South Texas Project
Units 1 and 2
Docket Nos. STN 50-498, STN 50-499
Response to Request for Additional Information Regarding Relief Request RR-ENG-3-10 for
Reactor Pressure Vessel Head Flange O-Ring Leakoff Lines Non-Destructive Examination
(TAC Nos. ME9863 and ME9864)

**Response to Request for Additional Information Regarding Relief Request RR-ENG-3-10
(TAC Nos. ME9863 and ME9864)**

Figure RAI-1: Simplified Sketch of O-Ring Leakoff Line off Reactor Vessel Flange

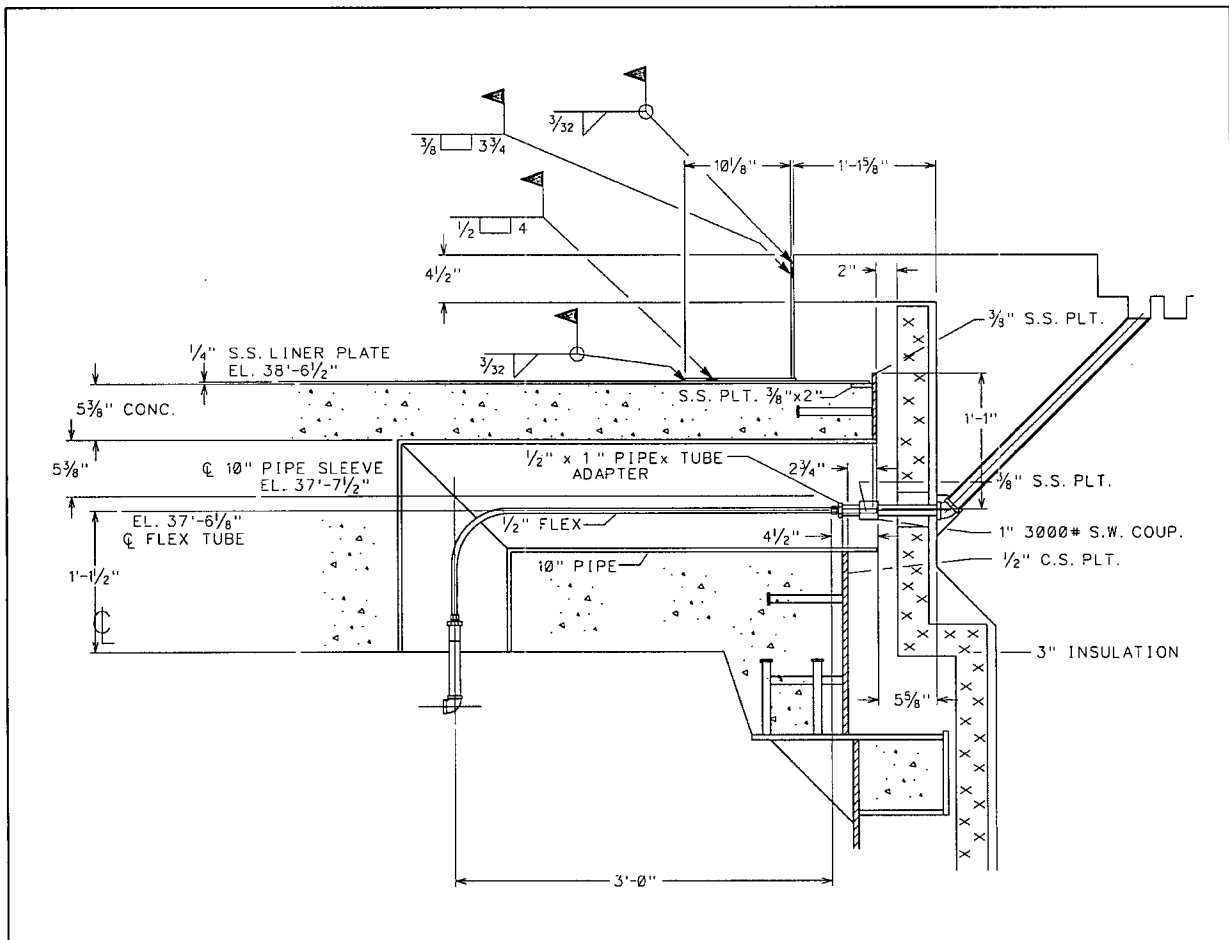
1. Section D of Relief Request RR-ENG-3-10 discusses the alternative examination of the O-ring leakoff lines. Please provide more details regarding the VT-2 visual examination of the leakoff lines when the reactor cavity is filled. For example:

- a. Describe exactly how an operator would visually examine the leakoff line (where and how).
 - b. Confirm that each leakoff line as shown in Figures 1 and 2 consists of a monitor tube of 1-inch in diameter coming off the O-ring area and is connected to a smaller piping of 3/4 inch in diameter.

- c. Discuss which portion of the piping and monitor tubes the operator will be examining to determine the potential leakage (i.e., discuss which portion of the leakoff line is accessible for visual inspection).

1.
 - a. After completing the system lineup to pressurize the ASME Class 2 portion of the line and achieving the 4-hour hold time, the operator would perform a visual test (VT-2) inspection of the leakoff line. VT-2 examination does not require removal of insulation. For segments of the line that are inaccessible for direct VT-2 visual inspection, examination would include inspection of the surrounding areas below the line for evidence of leakage as permitted by ASME Section XI Code, 2004 edition, IWA-5241(b). The flex hose and monitor tube segments that are inaccessible for direct VT-2 visual inspection are shown below on Figure RAI-1.
